Final EIR

Vista Lucia Project

State Clearinghouse Number 2020039056

VISTA LUCIA PROJECT
(ANNEXATION, PREZONING, SPECIFIC PLAN AND
NEIGHBORHOOD 1 TENTATIVE MAP)

Figure 4-3

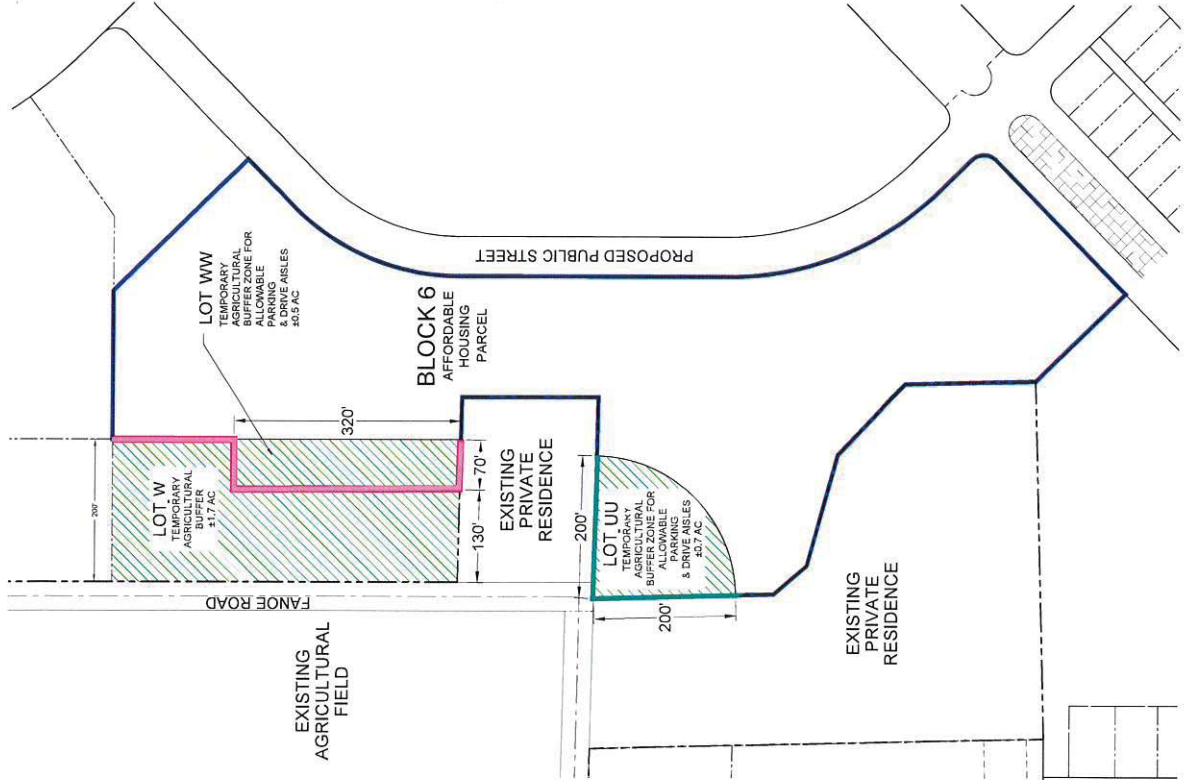
Background: Our office engaged in early consultation with the developer, Pembroke Development, at the developer's request, to discuss temporary agricultural buffers between the agricultural lands and the proposed high-density residential development depicted as *Area 6* in Draft EIR's *Figure 4-2* (enclosed as Attachment 1), further depicted as the brown area in the *Santa Lucia Neighborhood* in Draft EIR's *Figure 4-3* (enclosed as Attachment 2). Pembroke's request was to allow for some of the parking area to extend to portions of the proposed temporary agricultural buffers. From this early consultation, Pembroke agreed to our office recommendation of allowing some of the required parking spaces for the high-density residential development in portions of the temporary agricultural buffer areas, subject to incorporating a six (6) to eight (8) foot high fence or wall in the perimeter of the high-density residential development's parking lot areas as additional buffer protection. On July 18, 2023, Pembroke submitted an email to our department with an exhibit titled "*Block 6 Option*" (enclosed as Attachment 3) for our review and approval showing two locations for an 8-foot fence or wall at the rectangular shaped area of the temporary agricultural buffer and a 6-8 foot fence or wall at the triangular site of the proposed temporary agricultural buffer area. This exhibit showing both fenced areas in the agricultural buffers was acceptable and this was conveyed to Pembroke.

Attachment 2- Santa Lucia Neighborhood, Figure 4-3, Draft EIR
